Green Hill Solar Farm

Hydraulic Modelling Technical Note

BESS

Document Ref: 313532-REP-001

Figure 5: Comparison of modelled 1% AEP +13%CC flood extent and EA recorded flood outlines

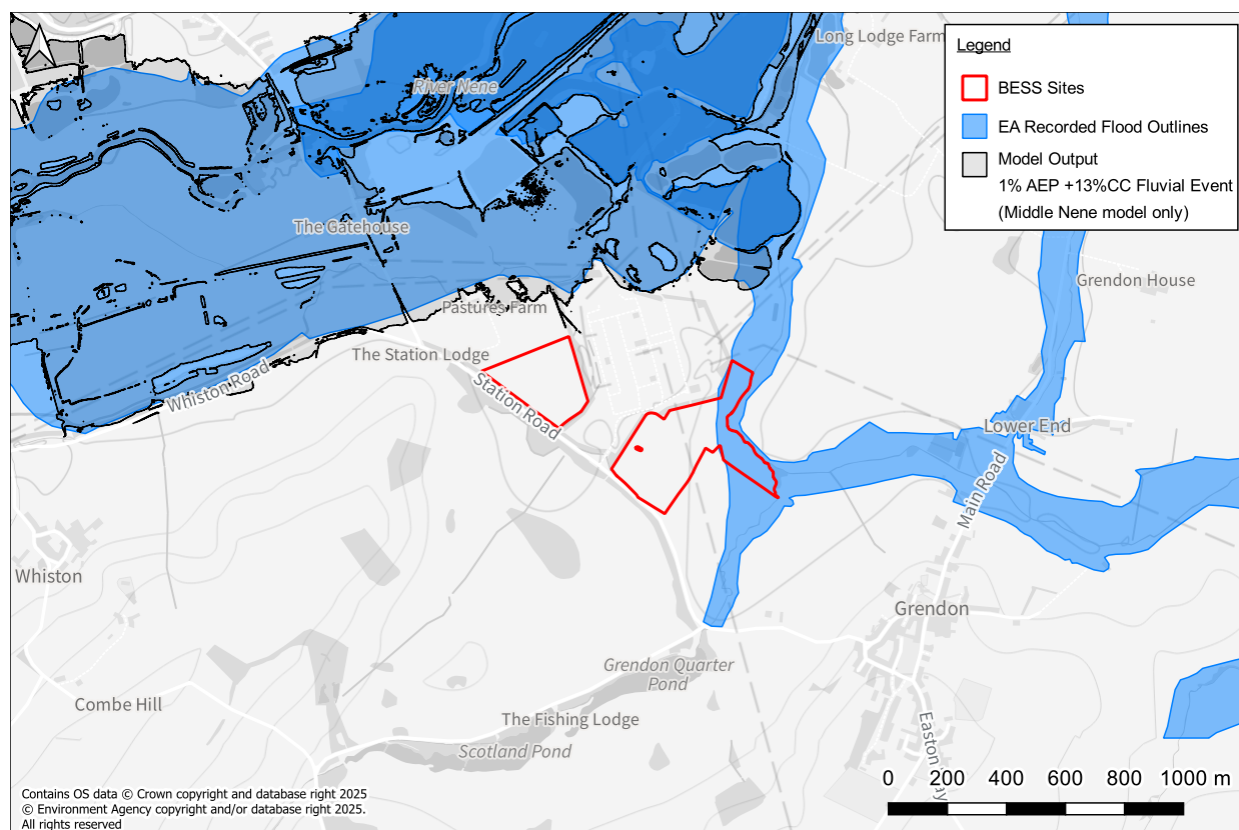
Comment	Review Comment	Arthian Response	Relevant Section References
5	Please include a map within the model report/Flood Risk Assessment which compares model results to recorded flood outlines. Recorded flood outlines held by the Environment Agency can be downloaded from the Defra Data Services Platform (environment.data.gov.uk)	The Applicant notes the Environment Agency's comments. Comparison maps of model results with recorded flood outlines will be prepared and included in the Hydraulic Modelling Report appended to the ES Appendix 10.1 Flood Risk Assessment and Drainage Strategy Report [APP-097] .	Figure 5
6	Please review the design flood extent in the vicinity of the land designated for the Battery Energy Storage System. The design flood extent is smaller when compared to the Environment Agency's existing 1% (1 in 100) Annual Exceedance Probability extent for the Nene (Halcrow, 2013). Whilst this does not necessarily indicate that the model schematisation is incorrect it does warrant a check to establish why these differences might be occurring, particularly given the sensitivities associated with the BESS.	The Applicant notes the Environment Agency's comments. Differences in design flood extent for the Battery Energy Storage System area compared to the existing Environment Agency model of the Nene will be reviewed, with outcomes documented in the Hydraulic Modelling Report appended to the ES Appendix 10.1 Flood Risk Assessment and Drainage Strategy Report [APP-097] .	2.4.4 2.5.2

- 2.4.4 Comparison of the modelled 1% AEP +13%CC flood extent with the EA recorded flood outlines dataset shows very good agreement, providing confidence in the model outputs. The comparison is presented in Figure 5.

Figure 8: Comparison of modelled 1% AEP +13%CC flood extent and EA recorded flood outlines

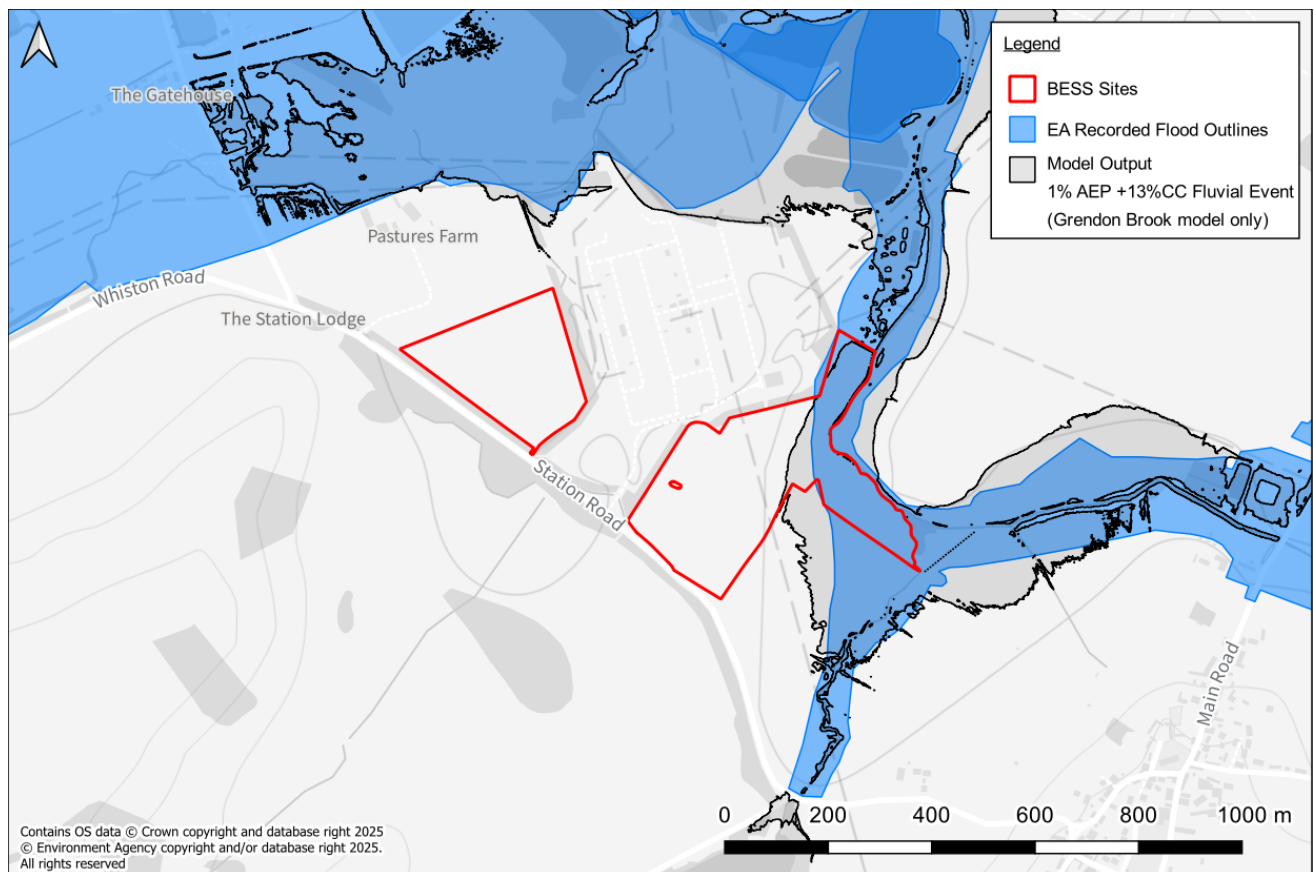
5	Please include a map within the model report/Flood Risk Assessment which compares model results to recorded flood outlines. Recorded flood outlines held by the Environment Agency can be downloaded from the Defra Data Services Platform (environment.data.gov.uk). Please see comment 15.3 within worksheet Model Performance within the attached spreadsheet.	The Applicant notes the Environment Agency's request. A comparison map of model outputs against recorded flood outlines (sourced from the Defra Data Services Platform) will be produced and included within the Hydraulic Modelling Report appended to the ES Appendix 10.1 Flood Risk Assessment and Drainage Strategy Report [APP-097] .	3.4

Comment	Review Comment	Arthian Response	Relevant Section References
6	Please review the design flood extent in the vicinity of the land designated for the Battery Energy Storage system. The design flood extent is smaller when compared to the Environment Agency's existing 1% (1 in 100) Annual Exceedance Probability extent for the Grendon Brook (Halcrow, 2013). Whilst this does not necessarily indicate that the model schematisation is incorrect it does warrant a check to establish why these differences might be occurring, particularly given the sensitivities associated with the BESS. Please see comment 15.7 within worksheet Model Performance within the attached spreadsheet.	The Applicant notes the Environment Agency's comments. Differences between the design flood extent and the existing Environment Agency model of the Grendon Brook will be reviewed as part of the modelling update, with outcomes reported in the Hydraulic Modelling Report appended to the ES Appendix 10.1 Flood Risk Assessment and Drainage Strategy Report [APP-097] .	3.4.4 3.5.2

- 3.4.4 Comparison of the modelled 1% AEP +13%CC flood extent with the EA recorded flood outlines dataset shows very good agreement, providing confidence in the model outputs. The comparison is presented in Figure 8.

- 3.5.2 The modelled flood extents are locally smaller than those shown in the EA Flood Zone mapping. Given the 1D nature of the modelling and the minor adjustments made relative to the overall model scale, these differences are likely to reflect localised interpolation effects, generalisation within the Flood Zone mapping, or subtle changes in topography between datasets rather than any systematic under-prediction. The updated model is based on the EA's original configuration and has been tested through a comprehensive sensitivity programme, which showed no undue sensitivity or instability. The results are therefore considered robust for the purpose of assessing flood risk to the Site.

Figure 14: Comparison of Arthian Field Drain model outputs and EA NaFRA2 CC SW Flood Map

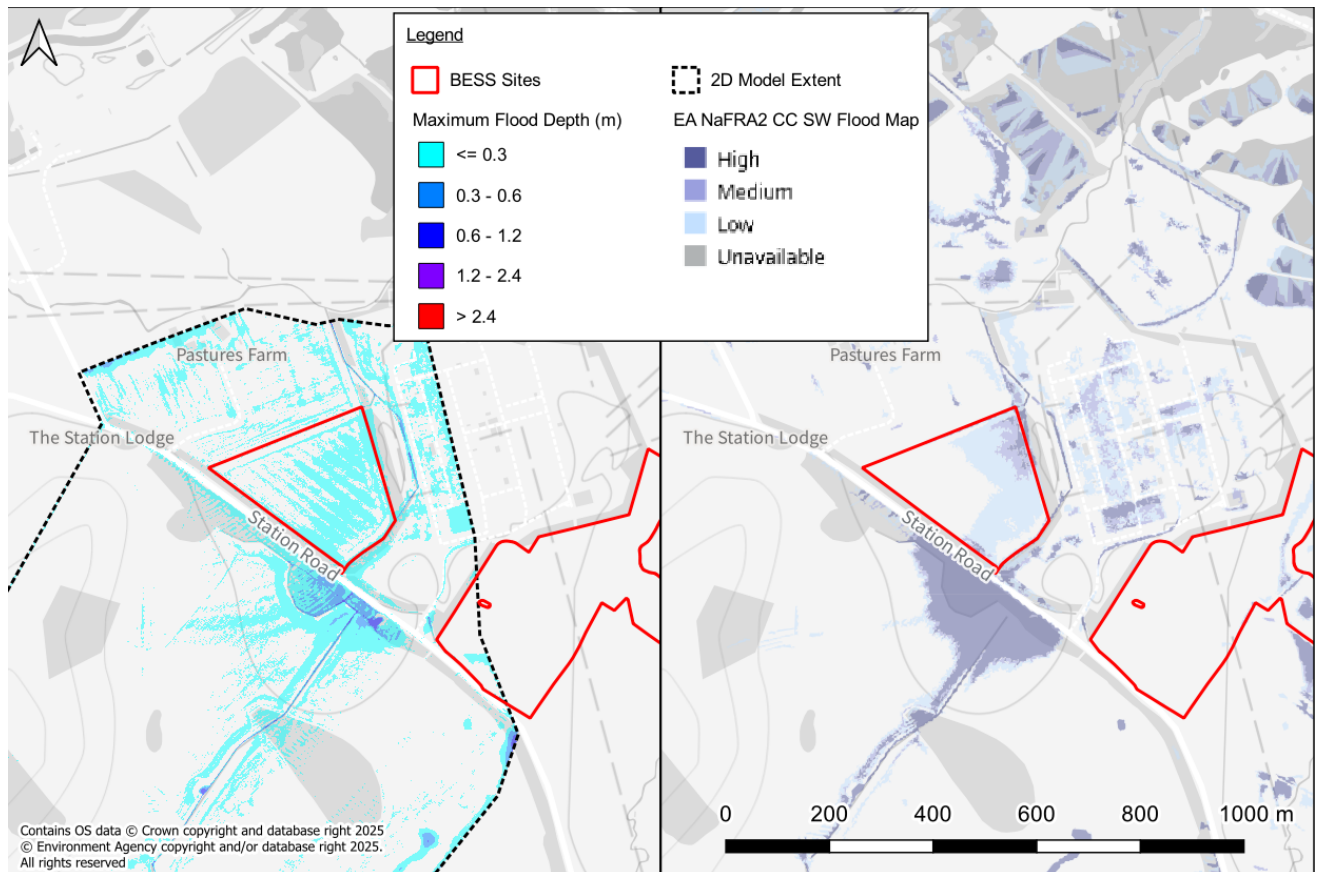
Comment	Review Comment	Arthian Response	Relevant Section References
6	The Environment Agency do not hold any recorded flood outlines for this unnamed ordinary watercourse, this does not mean that historic flooding has not occurred just that the Environment Agency do not hold any records of flooding. Do the Lead Local Flood Authority have any historic data to validate the model outputs against? Please see worksheet Model_Performance within the attached spreadsheet.	The Applicant notes the Environment Agency's comments. Enquiries have been made with the Lead Local Flood Authority regarding historic flood records for the unnamed ordinary watercourse. No such records have been identified to date, but the Applicant will continue to engage with the LLFA to confirm whether any information is available to support validation of the model outputs. Findings will be documented in the Hydraulic Modelling Report appended to the ES Appendix 10.1 Flood Risk Assessment and Drainage Strategy Report [APP-097] .	4.4.4

- 4.4.1 A review of the 2D log files shows that there are no comments, warnings or errors warranting attention.
- 4.4.2 Mass balance error statistics show the 2D mass balance error sits close to 0.0% for all simulations including sensitivity tests, as expected for a healthy TUFLOW HPC simulation.
- 4.4.3 There are no negative depths reported in any simulations.
- 4.4.4 The EA hold no historic records of flooding along this unnamed tributary therefore it was not possible to perform any comparison with the model outputs. However, results showed good agreement with the NaFRA2 CC surface water flood maps, providing confidence in the model setup. A comparison is presented in Figure 14.
